# 8850 Sunset Boulevard Project Final Environmental Impact Report

State Clearinghouse No. 2019090447

Final Environmental Impact Report

**Chapter 2 – Response to Comments.** During the public review period for the Draft EIR, written comment letters were received by the City and oral testimony was provided at public meetings. This chapter contains these comment letters, a summary of the oral testimony, and the City’s responses to the comments.

**EXISTING SITE AND DEMOLITION PLAN**

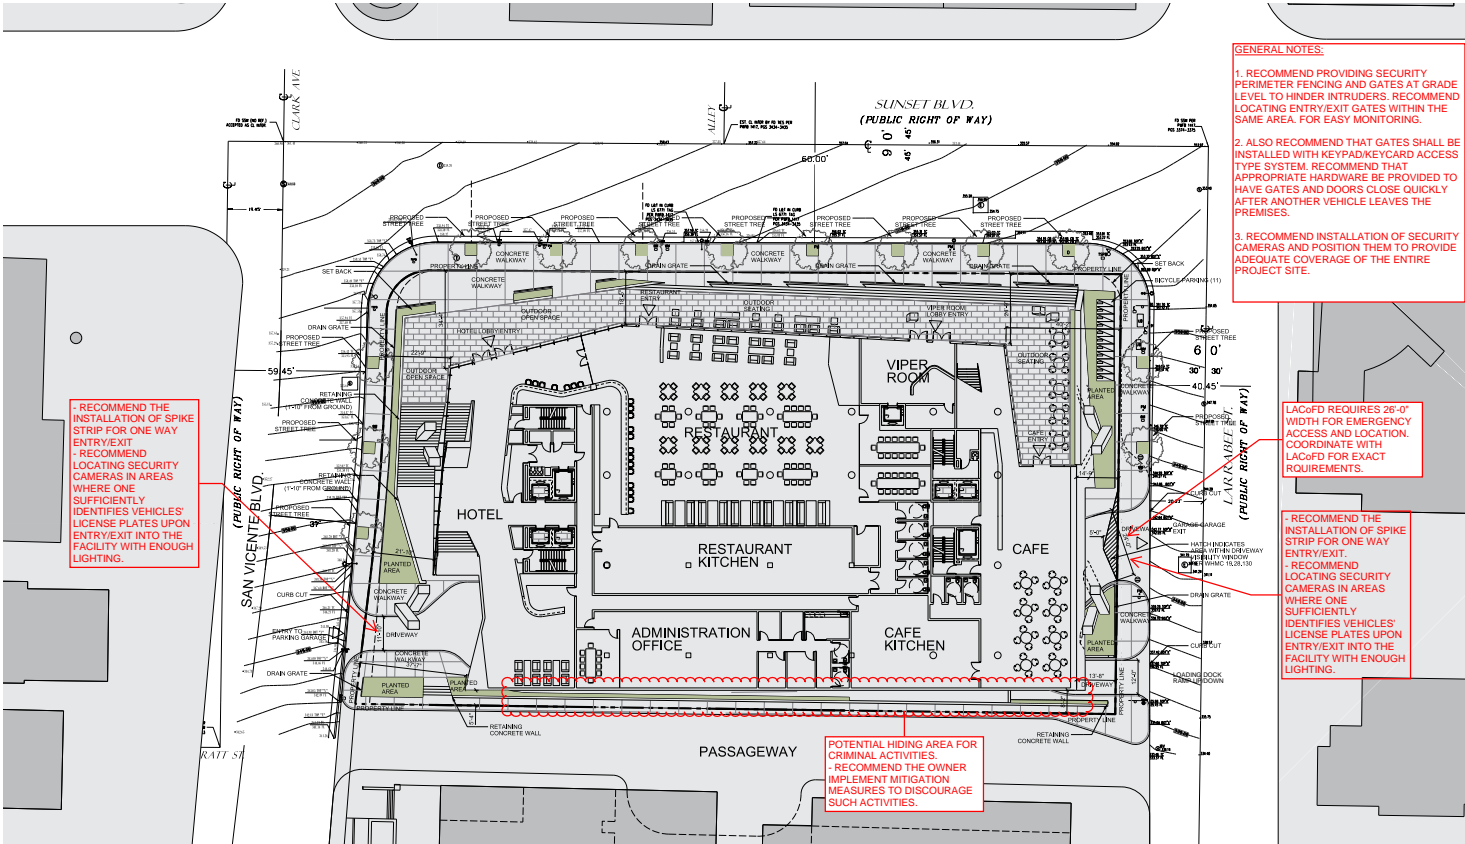
- GENERAL NOTES:**
1. RECOMMEND PROVIDING SECURITY PERIMETER FENCING AND GATES AT GRADE LEVEL TO HINDER INTRUDERS. RECOMMEND LOCATING ENTRY/EXIT GATES WITHIN THE SAME AREA. FOR EASY MONITORING.
  2. ALSO RECOMMEND THAT GATES SHALL BE INSTALLED WITH KEYPAD/KEYCARD ACCESS TYPE SYSTEM. RECOMMEND THAT APPROPRIATE HARDWARE BE PROVIDED TO HAVE GATES AND DOORS CLOSE QUICKLY AFTER ANOTHER VEHICLE LEAVES THE PREMISES.
  3. RECOMMEND INSTALLATION OF SECURITY CAMERAS AND POSITION THEM TO PROVIDE ADEQUATE COVERAGE OF THE ENTIRE PROJECT SITE.

**A2-8** This comment consists of design recommendations from the Sheriff's Department related to the provision of security cameras and other design features aimed at improving site security. These recommendations will be included in the Final EIR for review and consideration by decision makers. Additionally, the project applicant has agreed to implement recommendations provided in the comment to the extent applicable to and feasible for the project as approved by the City, including spike strips, surveillance, and adequate lighting.

**PARKING PLAN - B5**

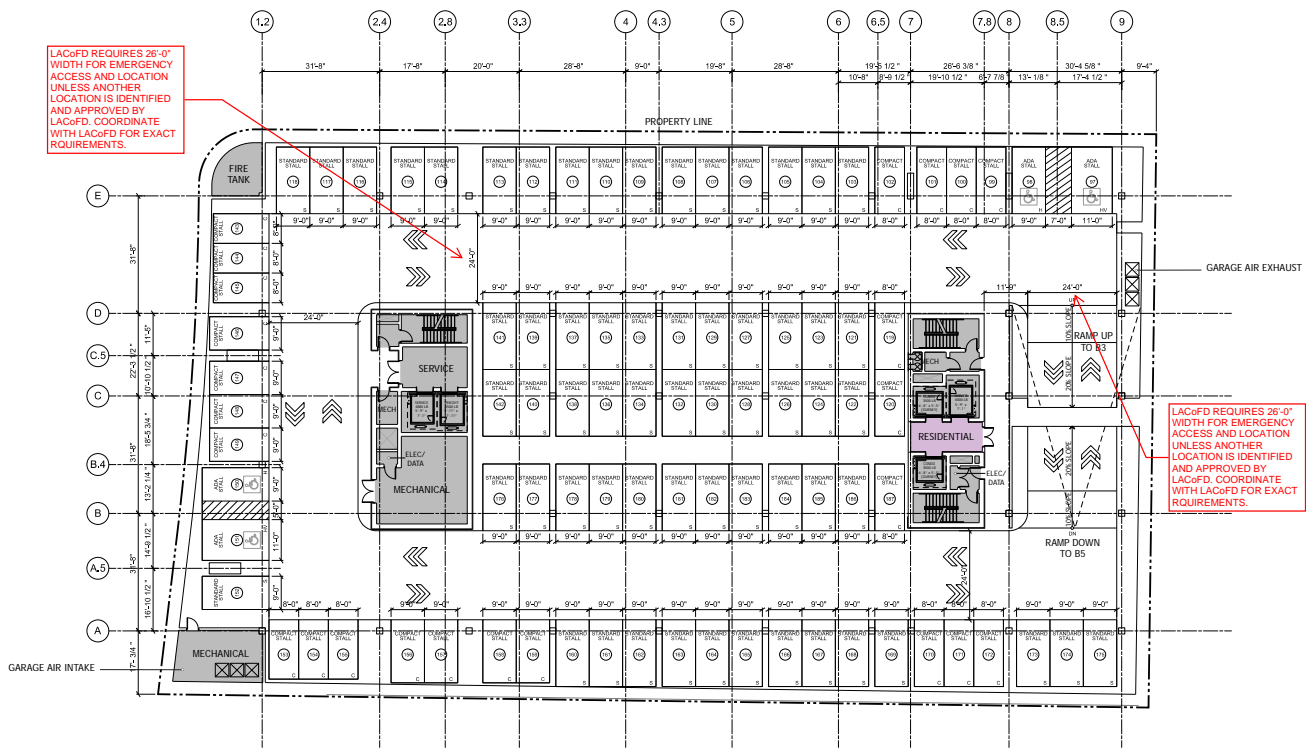
LACoFD REQUIRES 26'-0" WIDTH FOR EMERGENCY ACCESS AND LOCATION UNLESS ANOTHER LOCATION IS IDENTIFIED AND APPROVED BY LACoFD. COORDINATE WITH LACoFD FOR EXACT REQUIREMENTS.

**PARKING PLAN - B4**

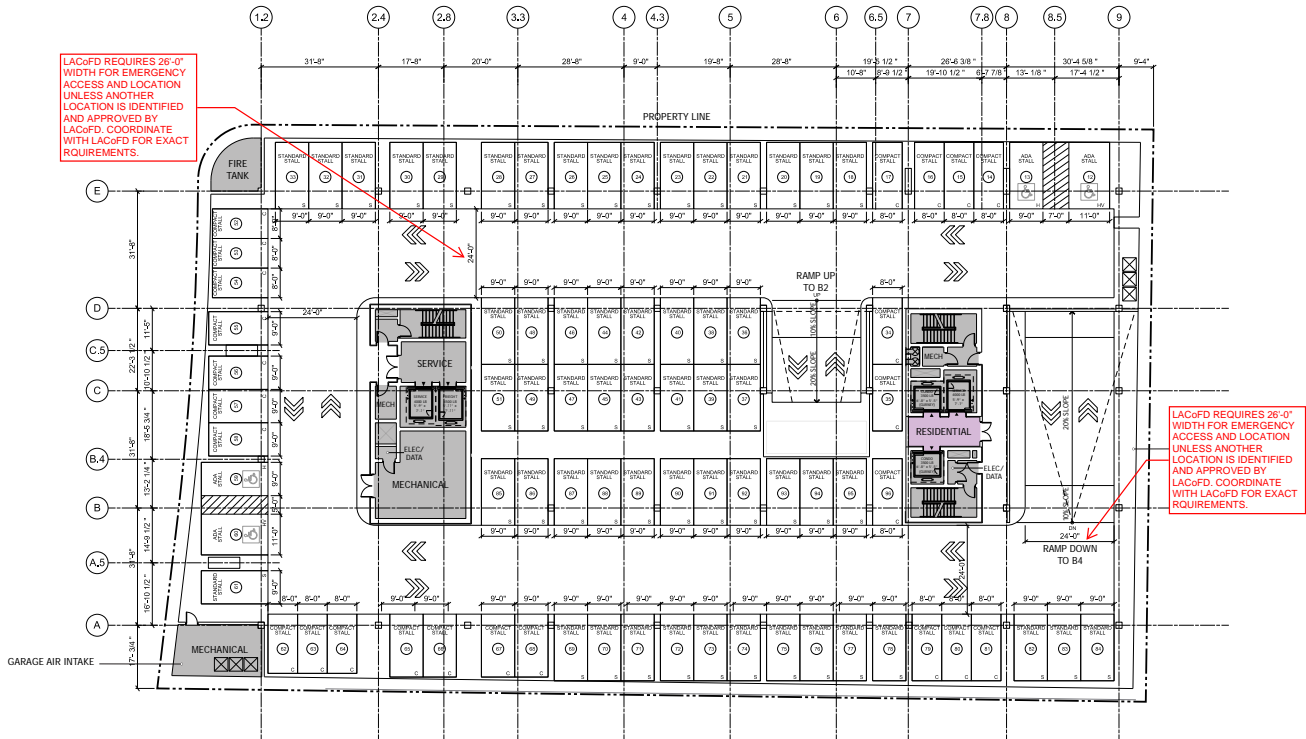
LACoFD REQUIRES 26'-0" WIDTH FOR EMERGENCY ACCESS AND LOCATION UNLESS ANOTHER LOCATION IS IDENTIFIED AND APPROVED BY LACoFD. COORDINATE WITH LACoFD FOR EXACT REQUIREMENTS.

**PARKING PLAN - B3**

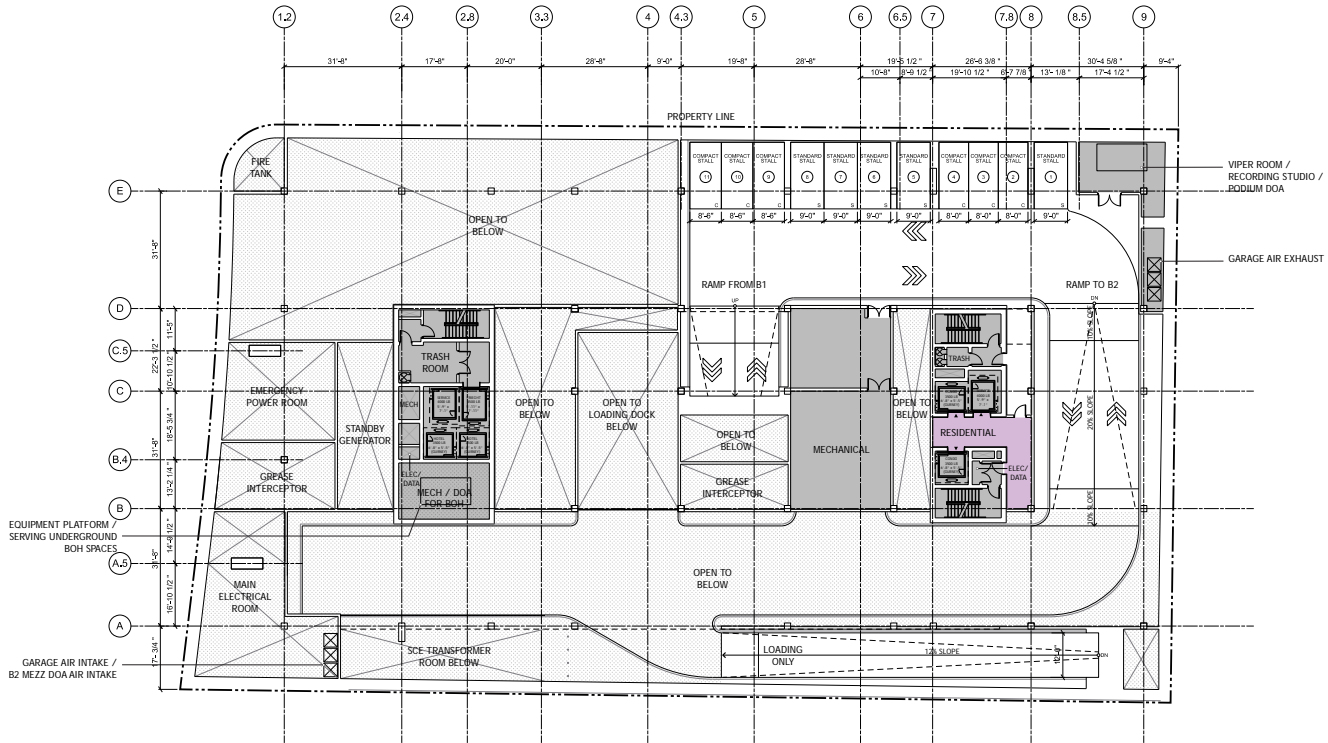
- RECOMMEND PROVIDING LOW-LEVEL SECURITY LIGHTING WITH MOTION SENSING CAPABILITIES THROUGHOUT THE PARKING STRUCTURE.
- RECOMMEND INSTALLATION OF SECURITY CAMERA WITH ADEQUATE COVERAGE OF EACH PARKING LEVEL.

**PARKING PLAN - B2 MEZZANINE**

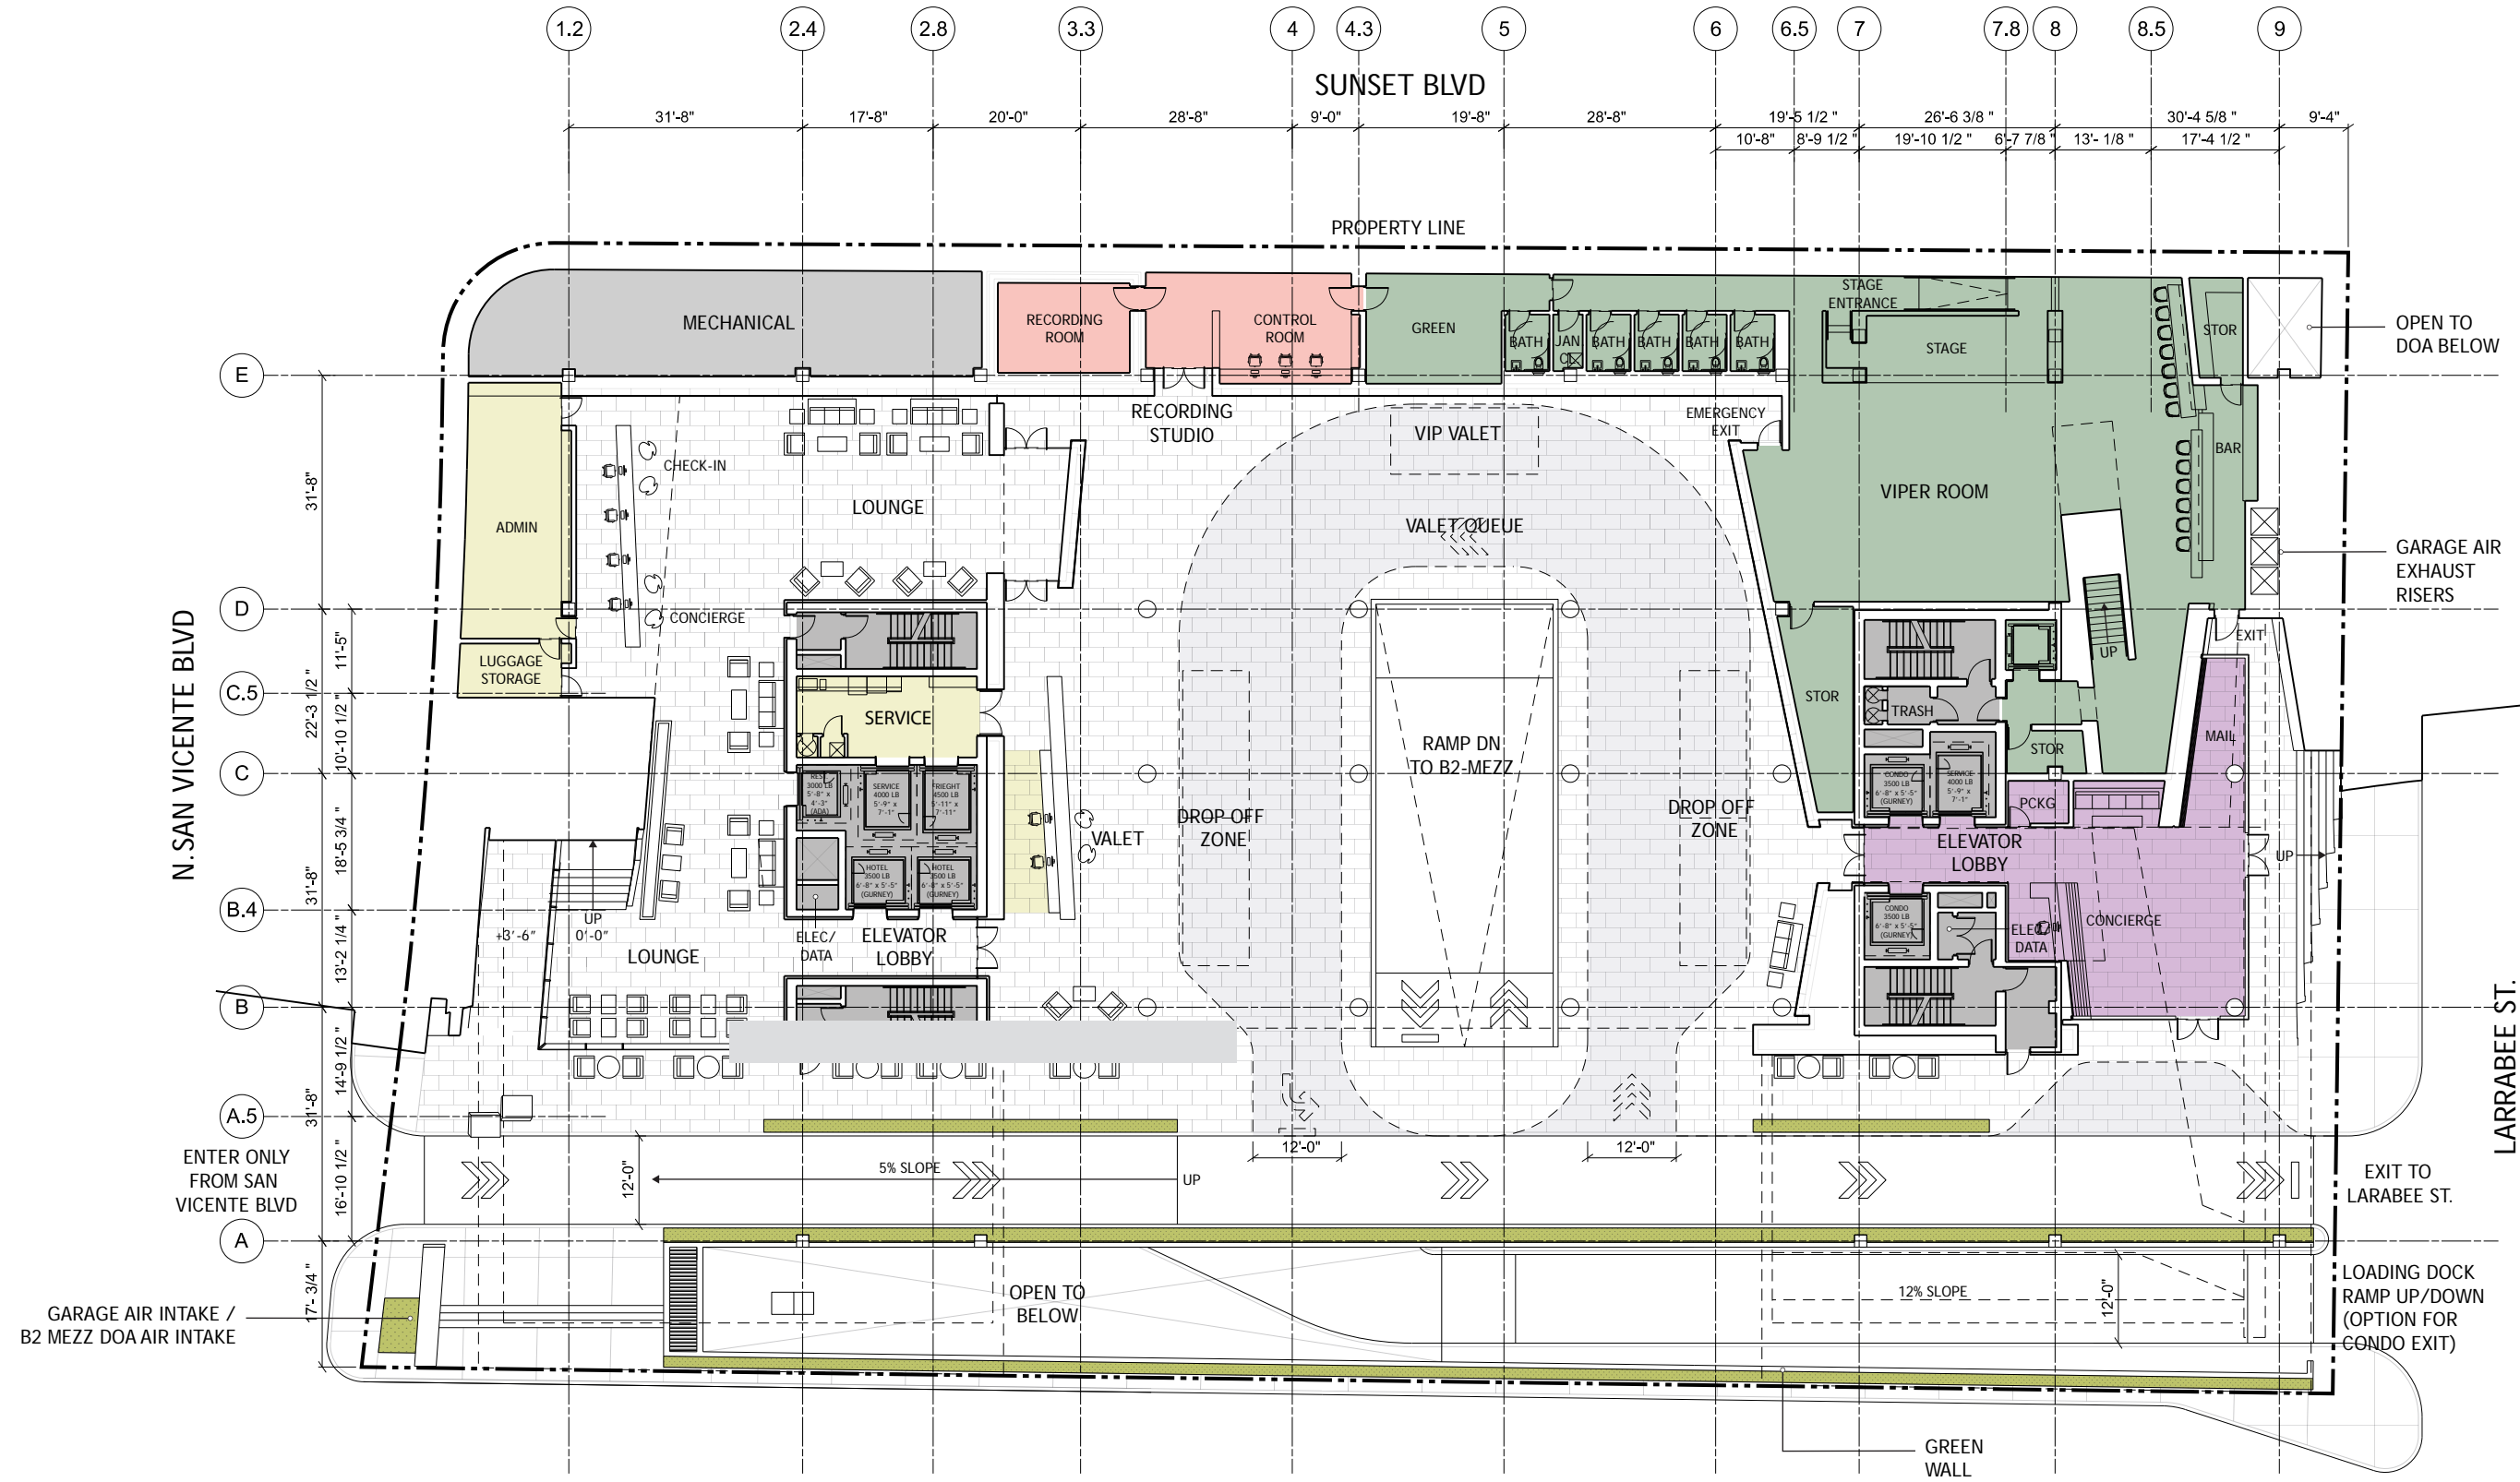
**NOTE:**  
 - RECOMMEND PROVIDING LOW-LEVEL SECURITY LIGHTING WITH MOTION SENSING CAPABILITIES THROUGHOUT THE PARKING STRUCTURE.  
 - RECOMMEND INSTALLATION OF SECURITY CAMERA WITH ADEQUATE COVERAGE OF EACH PARKING LEVEL.

# PARKING PLAN - B1

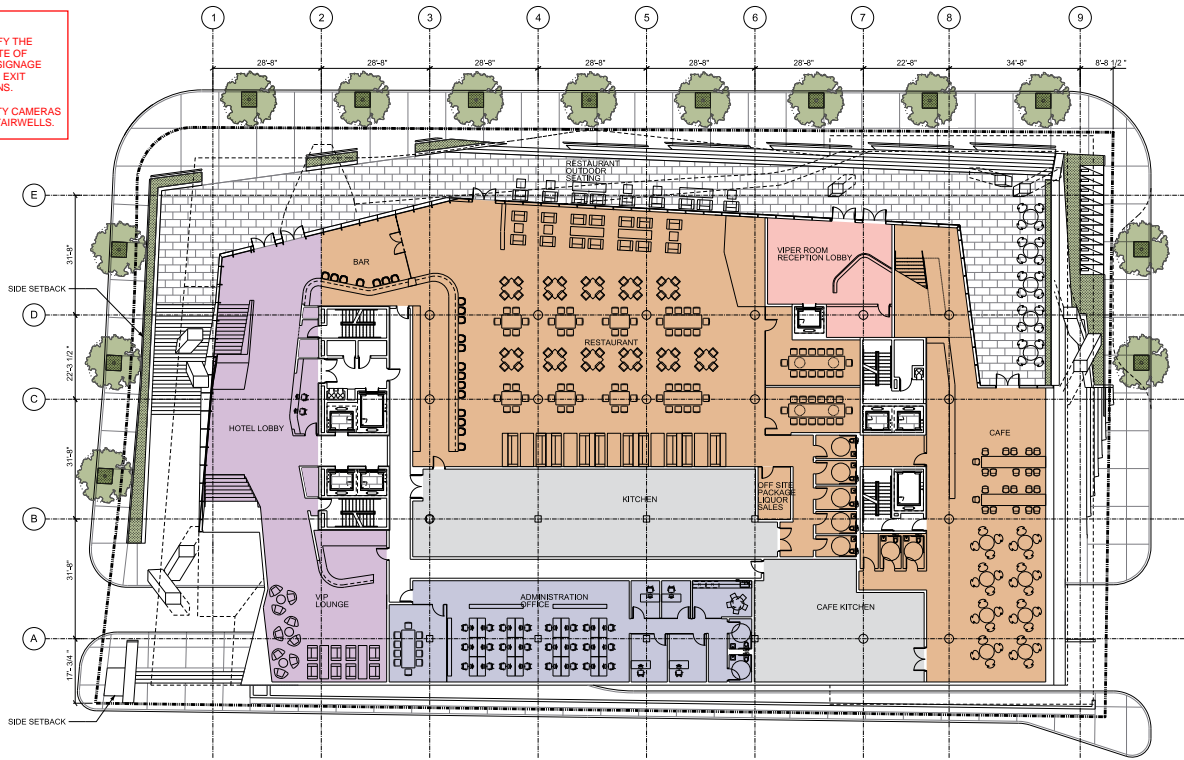
**NOTE:**  
 1. RECOMMEND TO CLEARLY IDENTIFY THE ACCESSIBLE AND EMERGENCY ROUTE OF TRAVEL WITH DISCERNABLE ROOM SIGNAGE WALL AND ILLUMINATED EXIT SIGNS, EXIT STAIRS SIGNS, AND ADA TOILET SIGNS.  
 2. RECOMMEND PROVIDING SECURITY CAMERAS AT ENTRY/EXIT, ELEVATORS, AND STAIRWELLS.

**GROUND FLOOR**

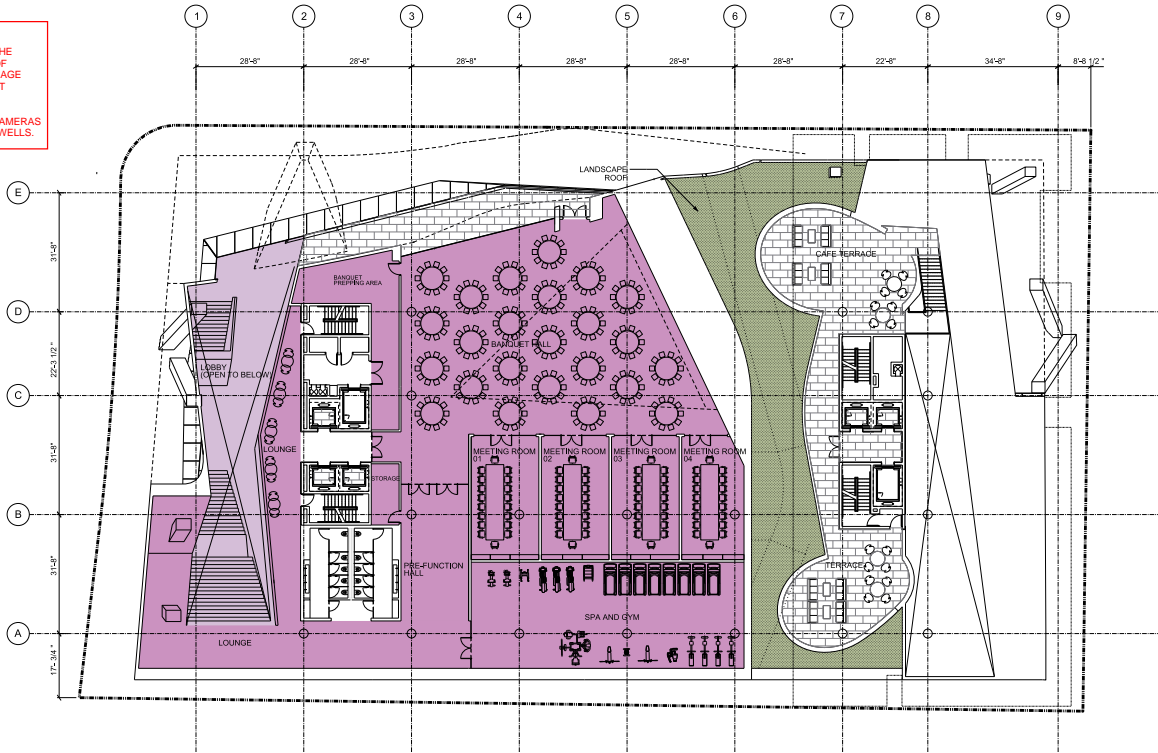
1. RECOMMEND TO CLEARLY IDENTIFY THE ACCESSIBLE AND EMERGENCY ROUTE OF TRAVEL WITH DISCERNABLE ROOM SIGNAGE WALL AND ILLUMINATED EXIT SIGNS, EXIT STAIRS SIGNS, AND ADA TOILET SIGNS.

**FL 07**

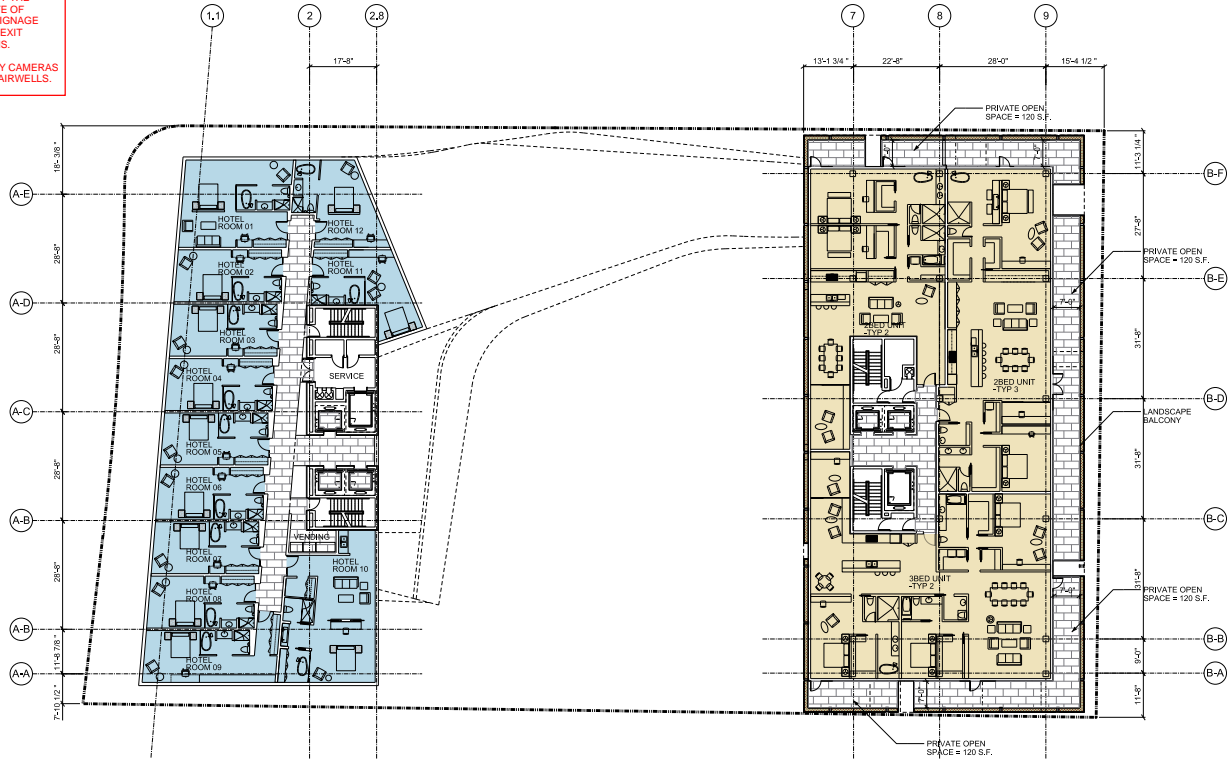
1. RECOMMEND TO CLEARLY IDENTIFY THE ACCESSIBLE AND EMERGENCY ROUTE OF TRAVEL WITH DISCERNABLE ROOM SIGNAGE WALL AND ILLUMINATED EXIT SIGNS, EXIT STAIRS SIGNS, AND ADA TOILET SIGNS.
2. RECOMMEND PROVIDING SECURITY CAMERAS AT ENTRY/EXIT, ELEVATORS, AND STAIRWELLS.
